Site work started on this project in 2019 with a temporary tin roof and side netting erected over the property to allow the old roof, including the timbers, to be removed. Although unusual to remove the roof timbers it made sense as the first floor ceiling was to be lowered so as to create a larger area with adequate headroom in the attic space as shown on drawings of the approved scheme, 2017/5939/P. When the temporary roof and netting was removed in early 2020 it became apparent that in re-constructing the roof various alterations to the drawings had been made;

Chair, Holly Lodge CAAC

Photograph of actual build

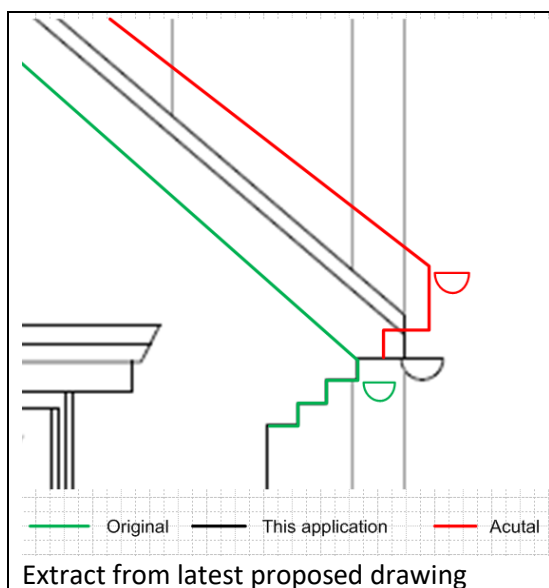
Raising the main roof ridge (1) was the first variance from the approved drawings noted and was reported to Camden Planning Enforcement in March and from whom we understood that the resolution was for the owners of 98 HWH to apply for retrospective planning approval. Initially a Non-Material Amendment was applied for and rejected, in part because the other discrepancies from the original drawings were being identified. Even now the proposed drawings do not accurately reflect what has been built, an example being the raising of the eaves. The drawings show only one additional step, the photograph shows two.
